<b>Well Name:</b> LUSK WEST DELAWARE UNIT	<b>Well Location:</b> T19S / R32E / SEC 20 / SENW / 32.6486605 / -103.7911631	<b>County or Parish/State:</b> LEA / NM
<b>Well Number:</b> 6	<b>Type of Well:</b> OIL WELL	<b>Allottee or Tribe Name:</b>
<b>Lease Number:</b> NMLC065710A	<b>Unit or CA Name:</b> LUSK WEST (DELAWARE) UNIT	<b>Unit or CA Number:</b> NMNM94514X
<b>US Well Number:</b> 3002534032	<b>Operator:</b> SHACKELFORD OIL COMPANY

**Notice of Intent**

**Type of Action:** Plug and Abandonment

**REVISED**

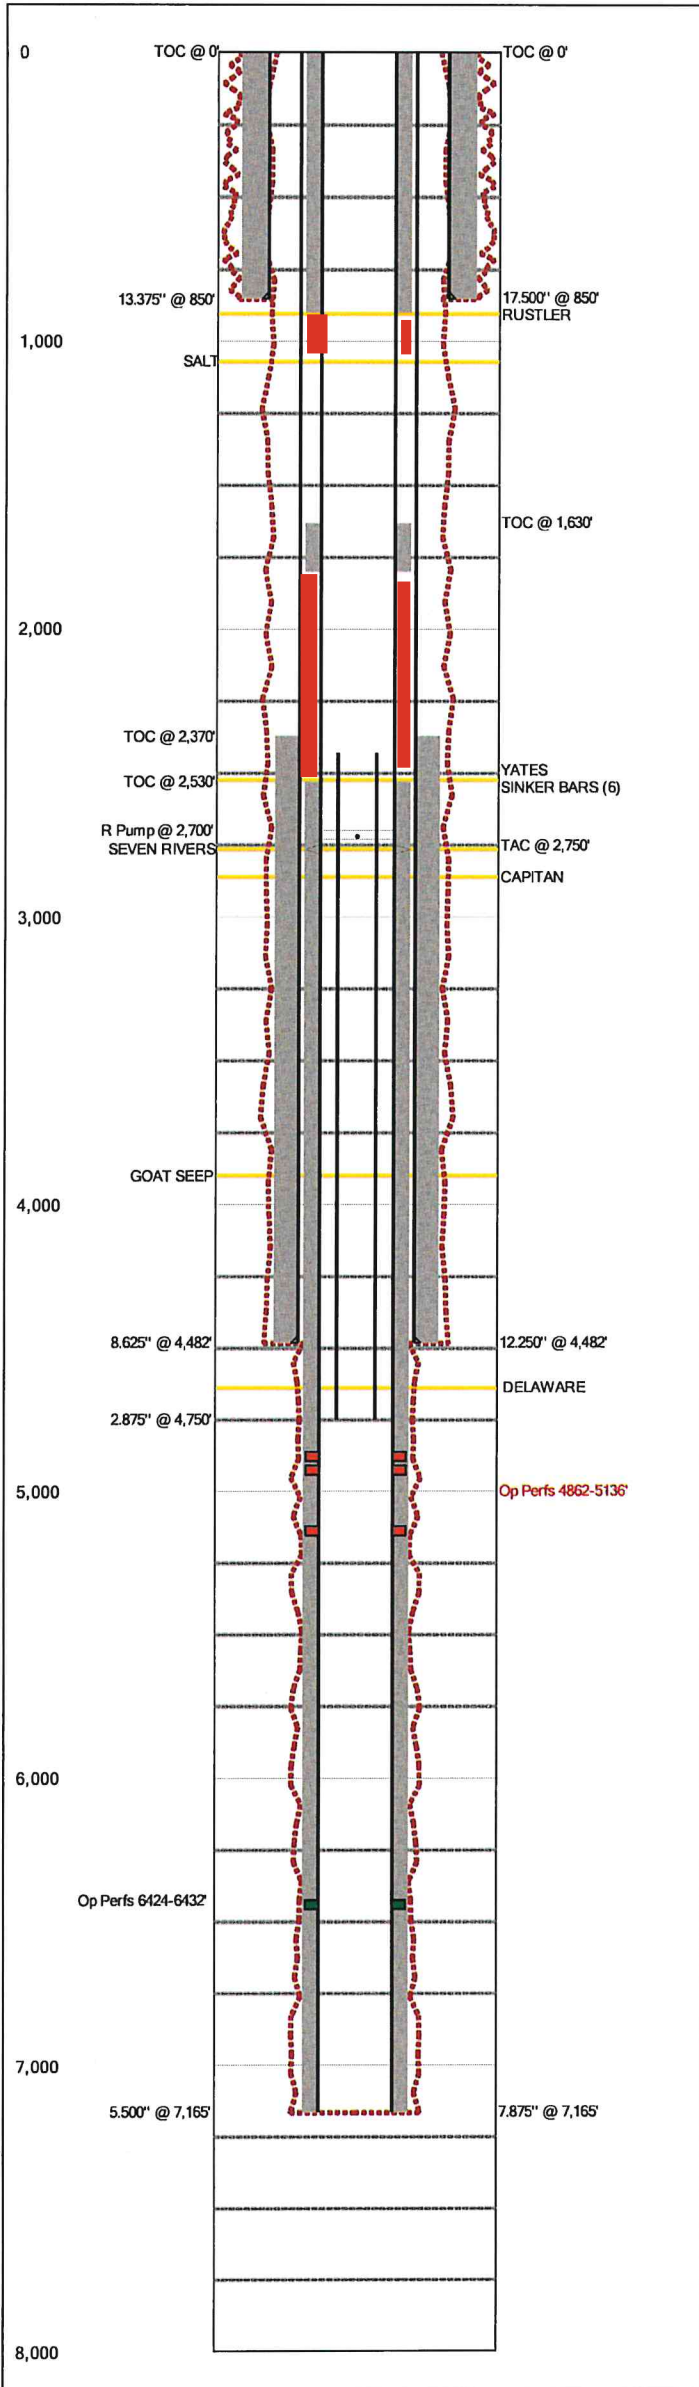
~~RIH - SET CIBP AT 2380' (50' ABOVE FISH/COLLAPSED CASING) - PUMP 25 SXS CLASS C CEMENT ON TOP OF CIBP - WOC/TAG  
 PUMP 30 SXS OF CLASS C CEMENT FROM 952-770 WOC/TAG (FORMATION/SHOE PLUG)  
 PUMP 20 SXS OF CLASS C CEMENT FROM 100 TO SURFACE - WOC/TAG (SURFACE PLUG)~~

~~CUT WELL HEAD AND WELD DRYHOLE MARKER - COMPLETE RECLAMATION OF LOCATION AND RESEED~~

### Plugging and Abandonment Procedures

1. RIH and dump bail 76' on top with fish with 8 sxs Class C cement. WOC and Tag.
2. Set CIBP at 2300'. Leak test CIBP at 500 psi for 30 minutes and spot 25 sxs class C on top.
3. Perf through 8 5/8" casing with deep penetration charge (avoid casing collar) at 1120' and circulate from 1120' to surface behind casing to surface with 497 sxs Class C cement. Verify cement at surface across all casing strings.
4. Cut well head and weld dry hole marker.

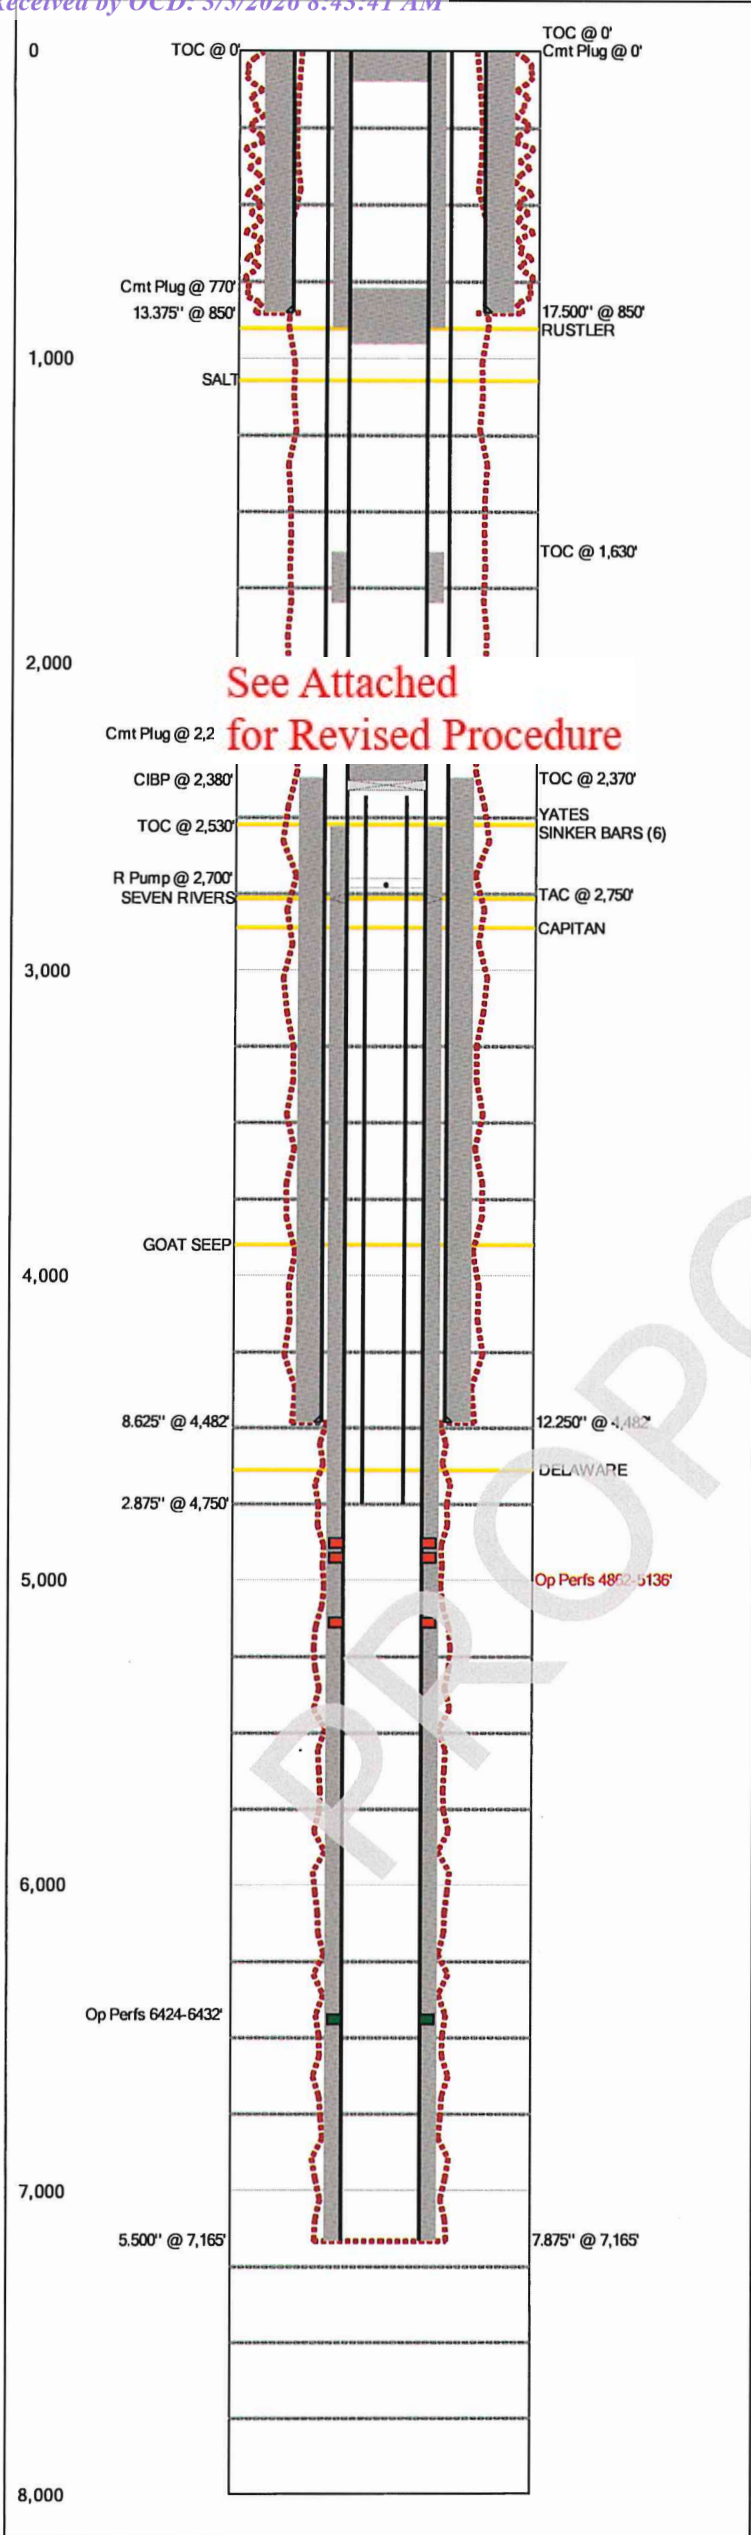
**REVISED**  
 2:36 pm, Mar 04, 2026

See Attached  
for Revised Procedure
